Meeting Minutes Transmittal/Approval  
Unit Managers Meeting: 100-HR-1/HR-3/DR-1 Operable Unit  
450 Hills Street, Room 47, Richland Washington

Meeting Held October 17, 1990

Meeting Summary and Summary of Commitments and Agreements  
100-HR-1/HR-3/DR-1 Unit Managers Meeting  
450 Hills Street, Room 47  
October 17, 1990

EXPANSION BOX DETAILS

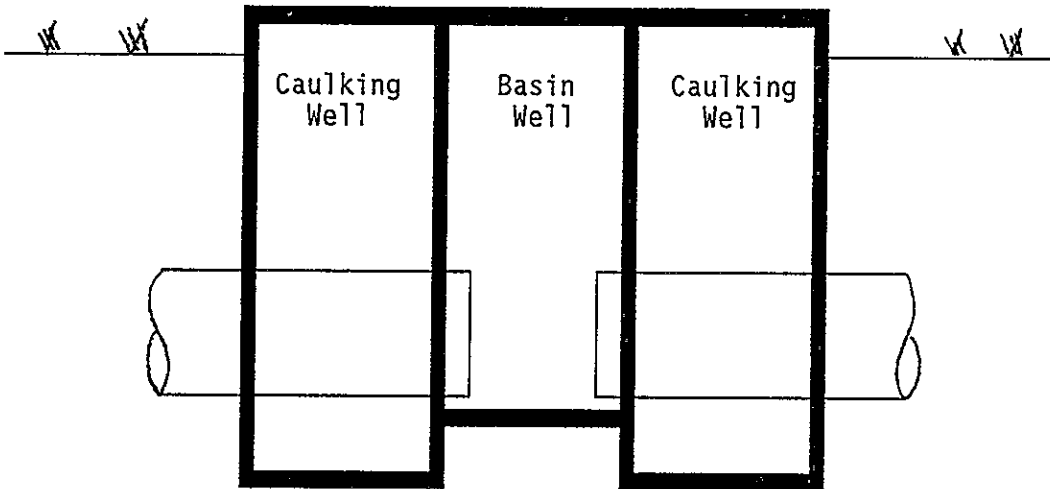
6. A presentation was given by Roberta Day. A handout entitled "Process Effluent Pipeline Integrity Assessment" is included as Attachment #6. The goal is to assess the integrity of the pipelines by inserting a camera into the pipelines. It is to be determined whether the camera

can detect splits, bad joints, etc. in order to identify sample locations. The pipelines are about 3000 feet long. The expansion boxes are planned to be opened on October 24 through 26. If the expansion boxes are filled with soil, camera access to the pipelines will be blocked. Access at the pipeline termination points or midline excavation will then be considered.

Alan Krug (WHC) stated that the camera inspection technique is a standard procedure. Larry Goldstein (Ecology) approves the first step of opening the expansion boxes, but wants to be informed if additional steps are required to obtain access to the pipeline.

In response to a question from Larry Goldstein, Alan Krug said that even if no breaches were detected with the camera, the work plan required drilling along the pipelines to search for leaks. It has not been determined whether the pipelines will have to be removed.

Larry Goldstein (Ecology) stated that Ecology and EPA must be notified of any excavation. Removing dirt from above the expansion boxes is not necessarily excavation, but Ecology expects appropriate guidelines such as EIIs to be followed and also expects the proposal for this investigation to clearly define the health and safety documentation that will be used.
